MILITARY SPECIFICATION

SEMICONDUCTOR DEVICE, TRANSISTOR, PNP, GERMANIUM, HIGH-FREQUENCY
TYPE 2N334

This amendment forms a part of Military Specification MIL-S-19500/27E, dated 12 February 1970, and is approved for use by all Departments and Agencies of the Department of Defense.

FIGURE 2. Gauge for lead and tab location for transistor type 2N384.

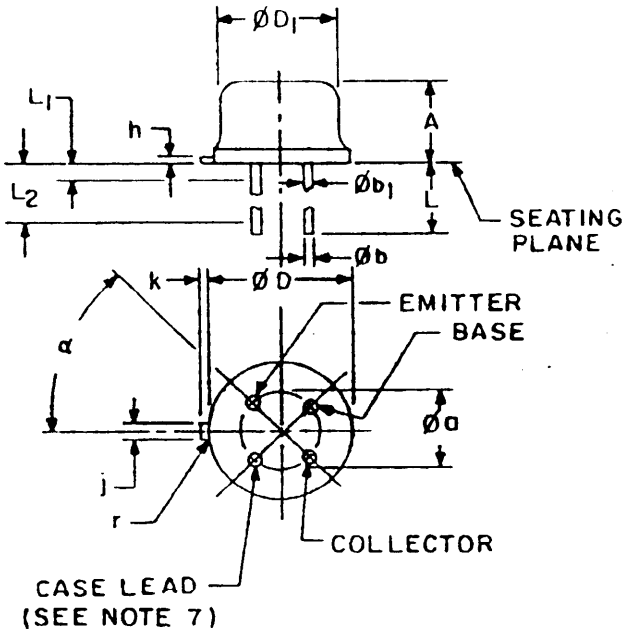
FIGURE 1: Delete and substitute the new figure 1 shown on page 2 of this amendment. Add figure 2 shown on page 3 of this amendment.
